ATTACHMENT 1

A. DESCRIPTION OF THE TECHNICAL SPECIFICATION AMENDMENT REQUEST

The proposed amendment changes the Shutdown Margin versus Cold Leg Temperature curve as set forth in Technical Specification (T.S.) 3.1.1.2. The change is to the Hot Zero Power endpoint. The change is from  $6.0\% \Delta\rho$  to  $6.5\% \Delta\rho$ .

FIGURE 3.2-2a

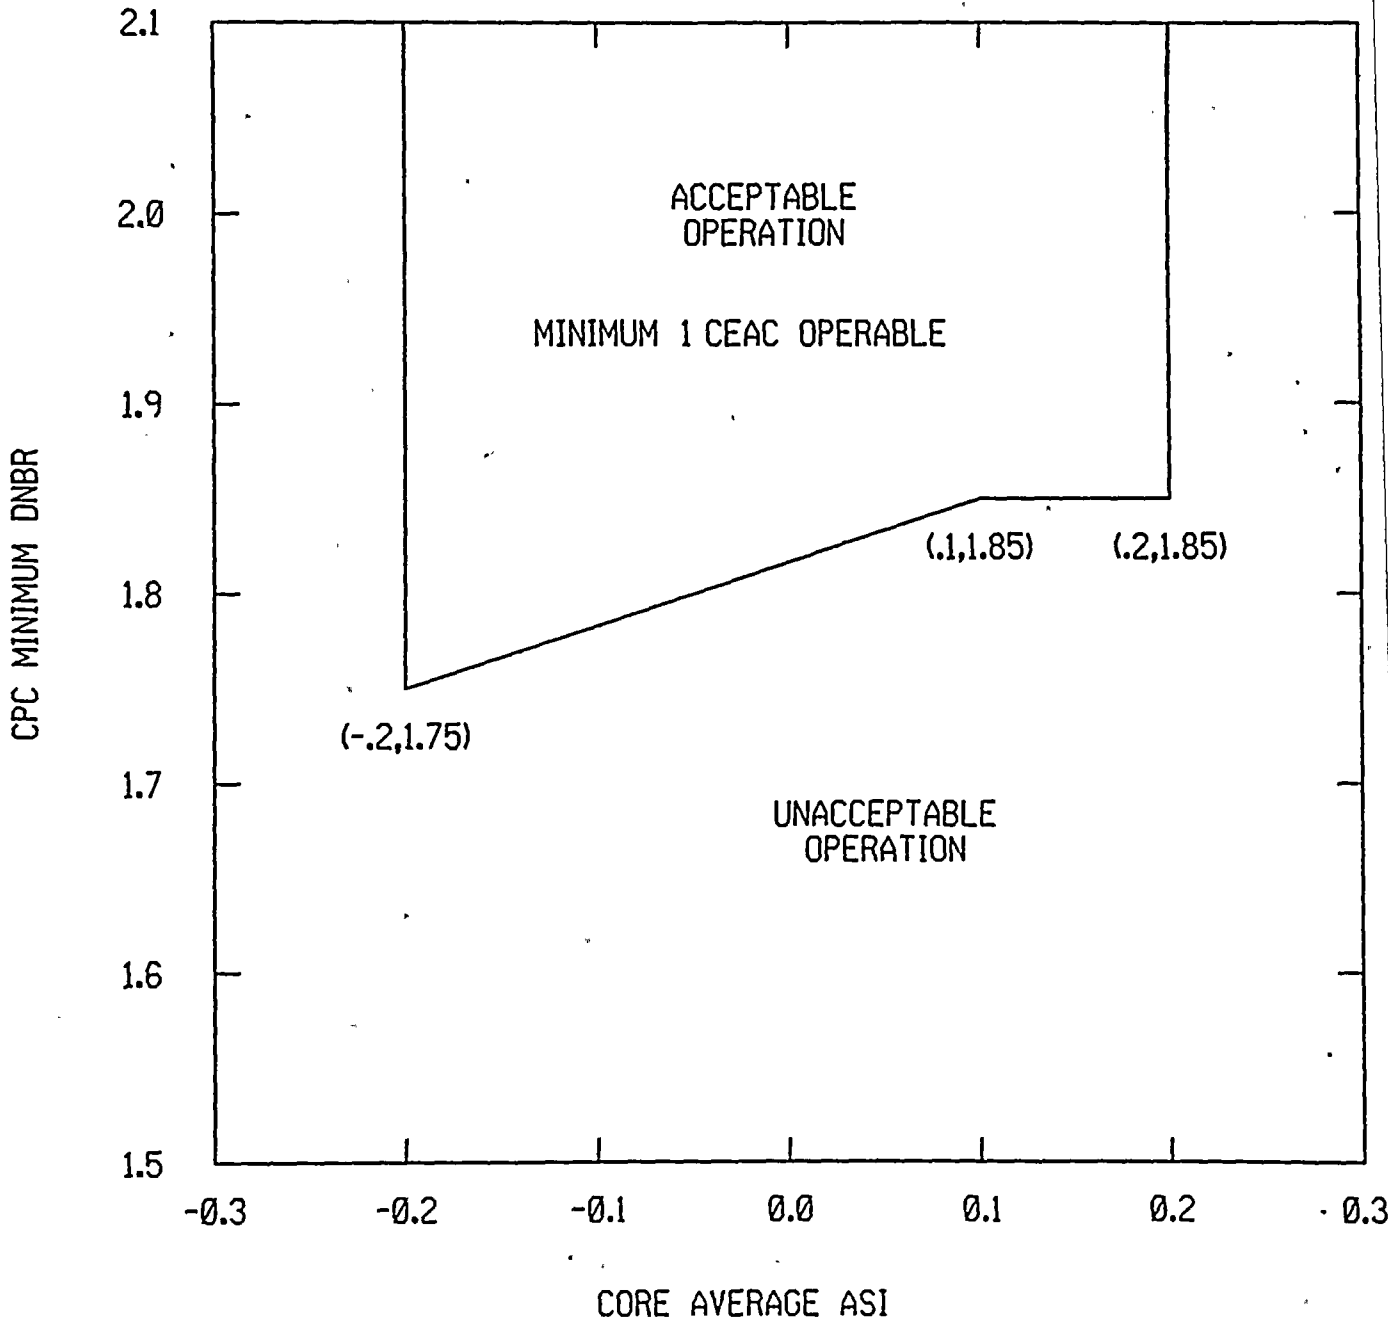
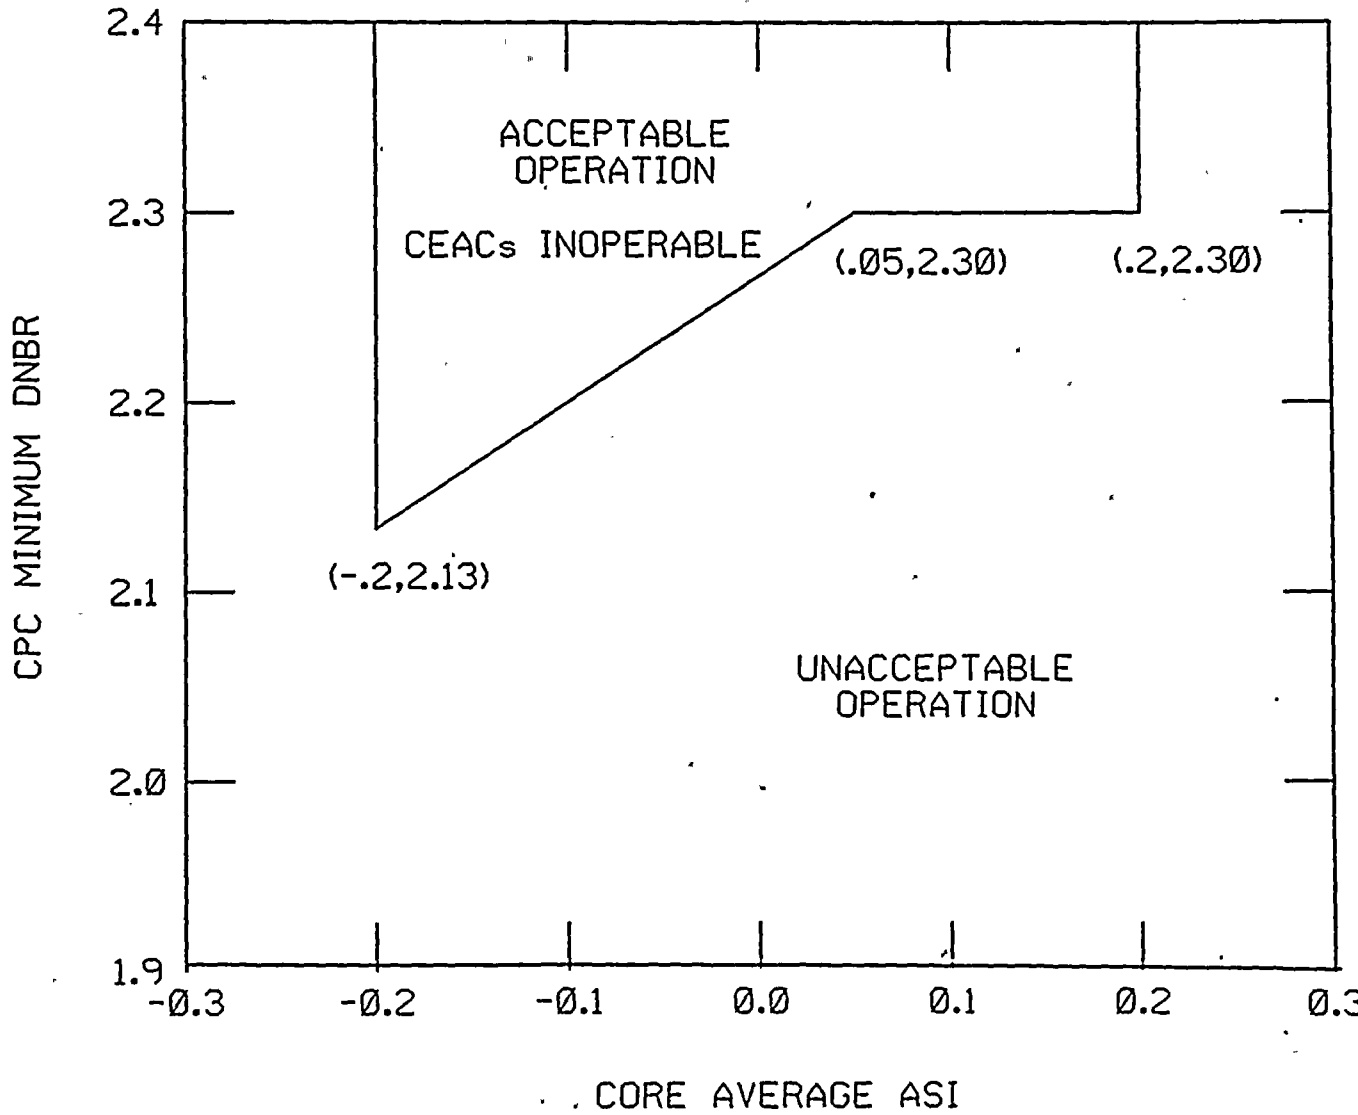
- 1. As indicated by COLSS calculated core power exceeding the appropriate COLSS calculated power operating limit; or
- 2. With COLSS out of service, operation outside the region of acceptable operation of Figure 3.2-2 or 3.2-2<sup>2a</sup>, as applicable;

4.2.4.2 The DNBR shall be determined to be within its limits when THERMAL POWER is above 20% of RATED THERMAL POWER by continuously monitoring the core power distribution with the Core Operating Limit Supervisory System (COLSS) or, with the COLSS out of service, by verifying at least once per 2 hours that the DNBR, as indicated on any OPERABLE DNBR channel, is within the limit shown on Figure 3.2-2 or Figure 3.2-2<sup>2a</sup>.

FIGURE 3.3-1

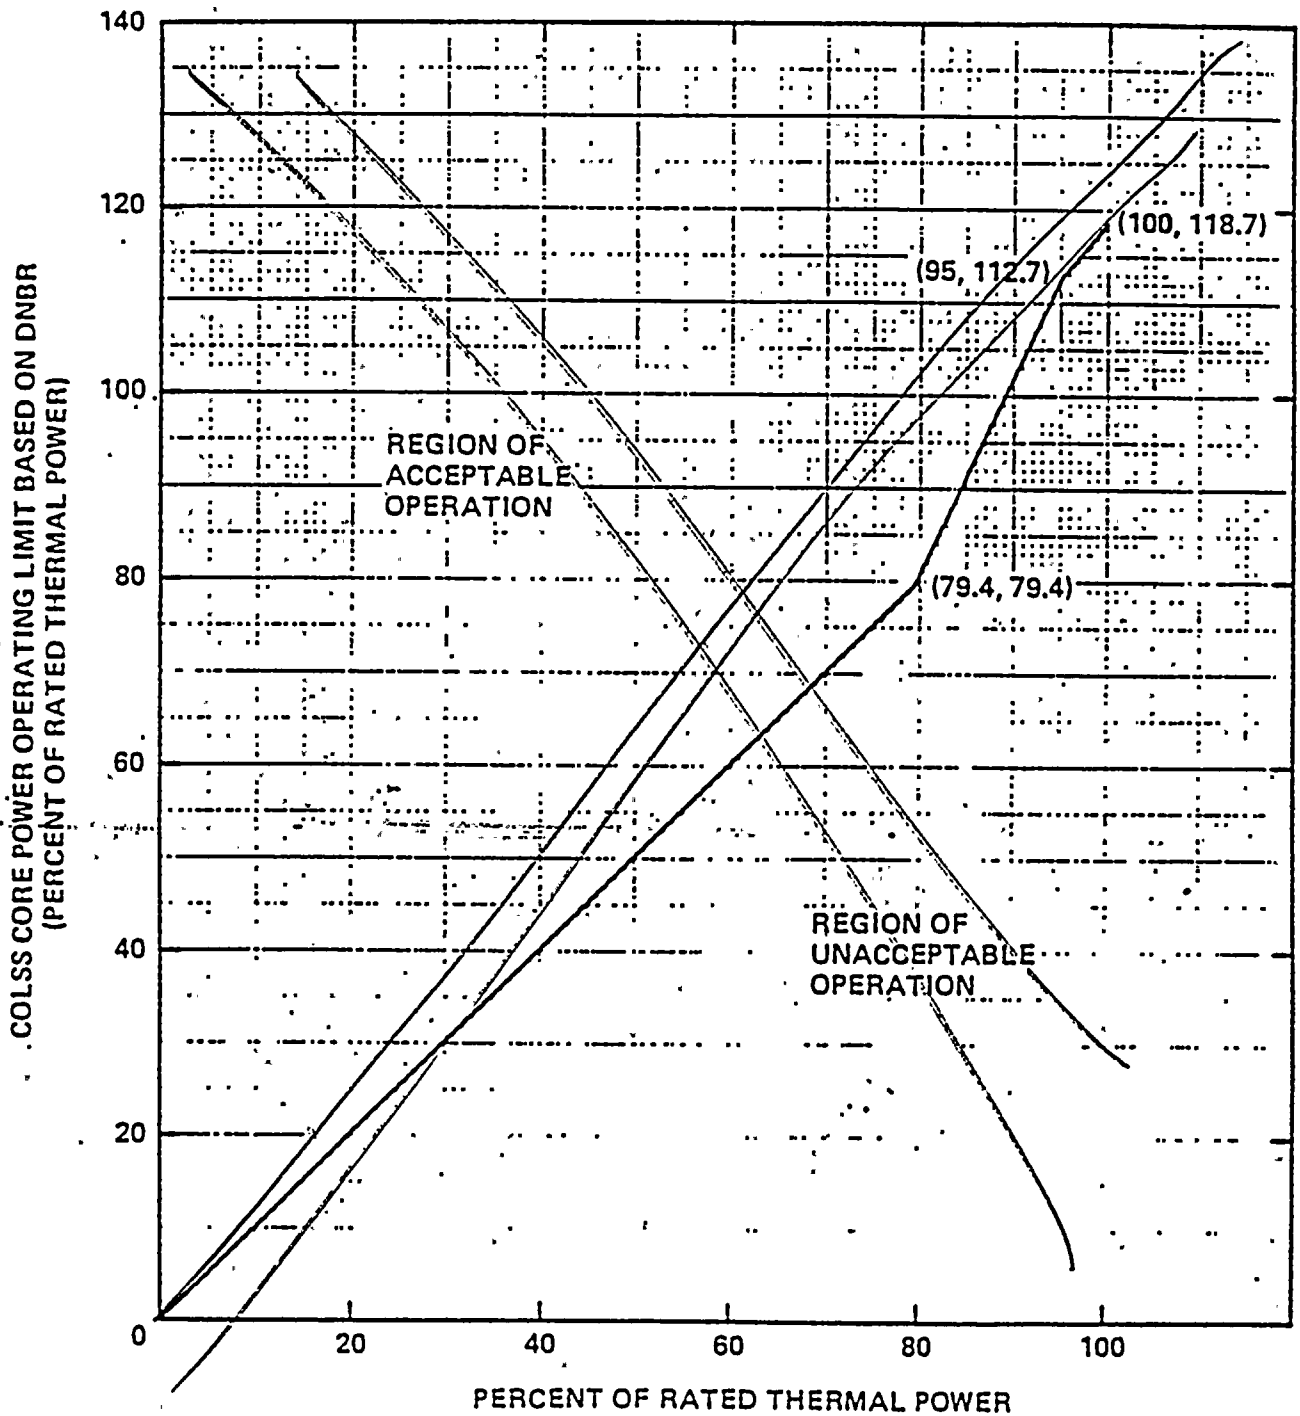
T.S. 3.3.1-(1) Removes references to the operation of the reactor with both CEACs inoperable and with or without COLSS inservice, and (2) deletes the graph of DNBR margin operating limit, Figure 3.3-1, based on COLSS for both CEACs inoperable. These changes are a result of being incorporated into the proposed T.S. 3.2.4

~~a) Operation is restricted to the limits shown in Figure 3.3-1. The DNBR margin required by Specification 3.2.4 is replaced by this restriction when both CEAC's are inoperable and COLSS is in operation.~~

FIGURE 3.2 - 1A  
AZIMUTHAL POWER TILT LIMIT  
VS  
THERMAL POWER  
(COLSS IN SERVICE)

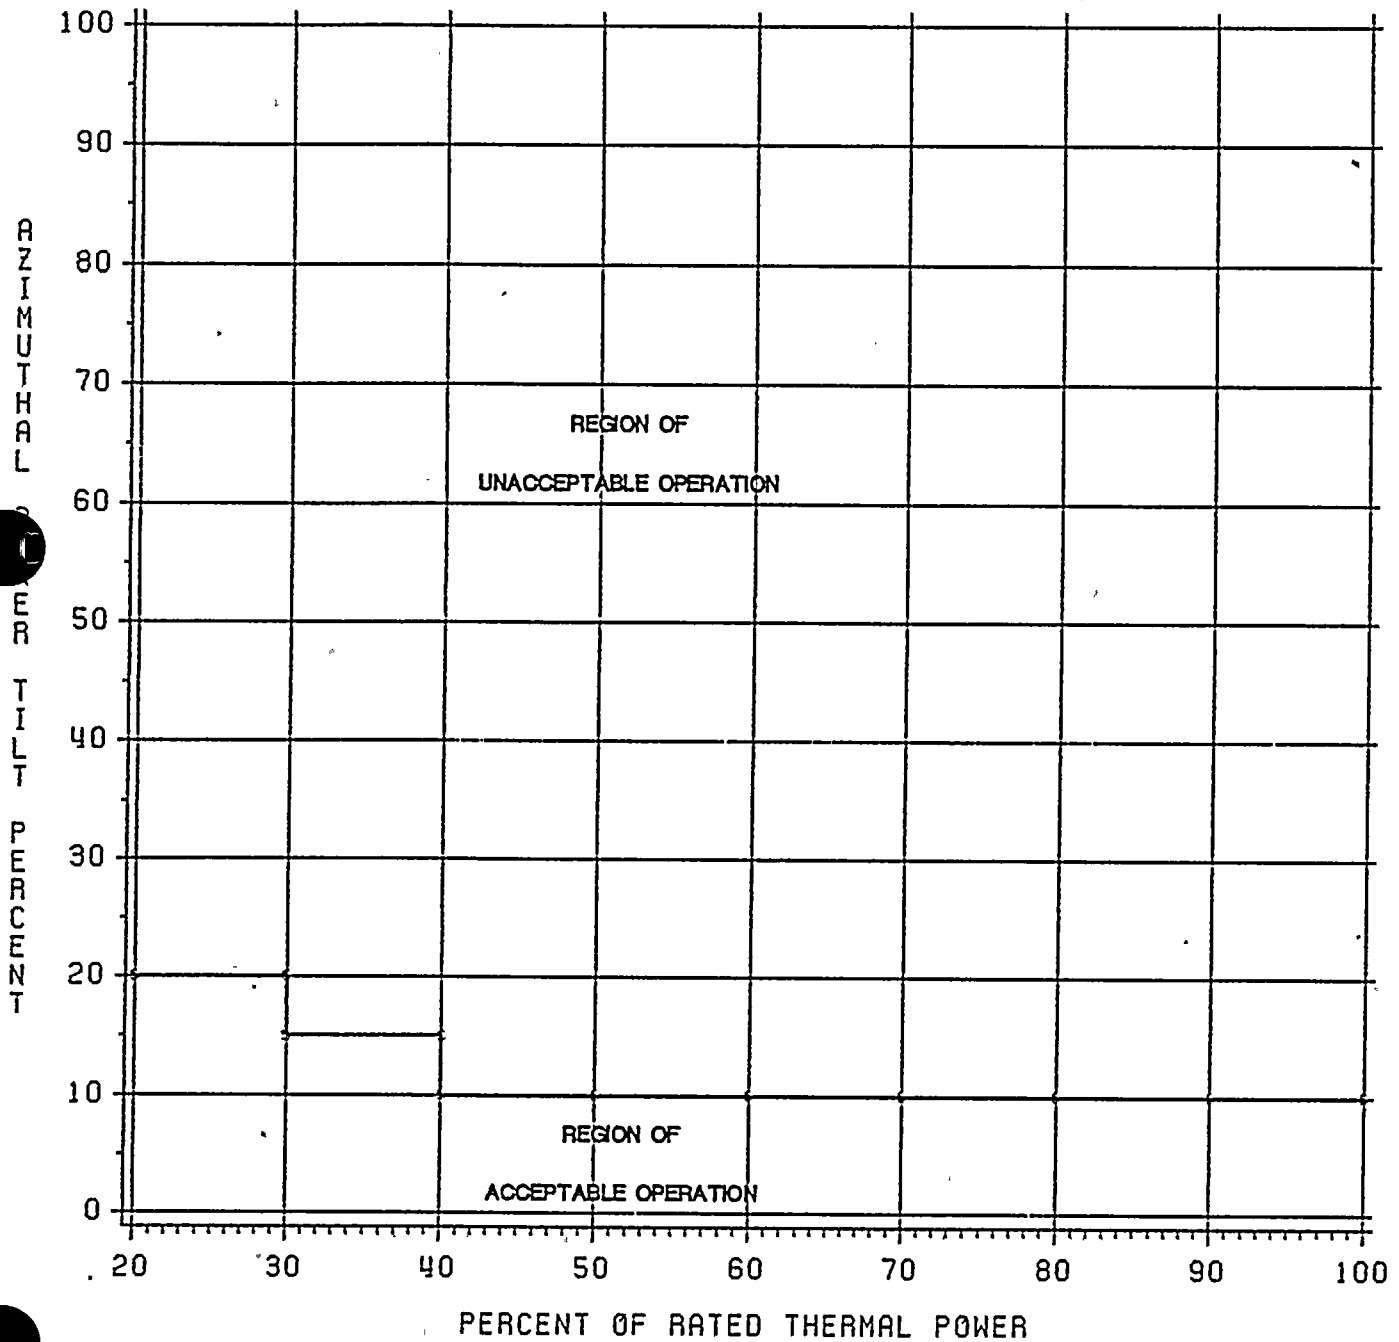
The limit in Figure 3.2-1A with COLSS in service or 0.10 with COLSS out of Service
